From: [Ross Pearson](#)
To: [Keyes, Jamie, EMNRD](#); [Harley Davis \(HCDAVIS@blm.gov\)](#)
Subject: Wattam #6H SWD Clean-up for Cross Border Resources
Date: Friday, April 08, 2016 1:13:30 PM
Attachments: [20160408130541880.pdf](#)

Wattam Battery & SWD Station

Revised BLM plan 4/7/2016

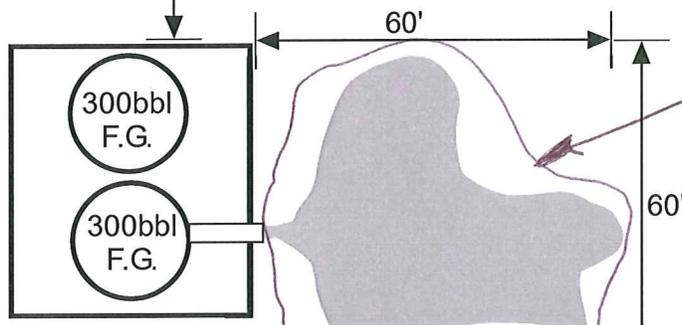
I received a phone call from Al Collar (Geologist) and Ruben Sanchez (AFM) with BLM Roswell office. They have reduced the scope of the clean-up. They only want to scrape the location pad one to two inches. The BLM wants to remove the spill without breaking through the hardened caliche pad. As far as the 21' by 30' puddle area (see attached pdf diagram), the BLM would like the contaminated area dug down 1 to 2 feet, and two samples taken in the pit area. Two more samples need to be taken in a natural uncontaminated setting to establish base line chlorides. Al Collar plans to be on site during the "dig and haul" process.

Limit Scrapping to 1" or 2"

Dig down 1' to 2'
 • Take two samples in the affected area, and two samples in a "natural" setting.
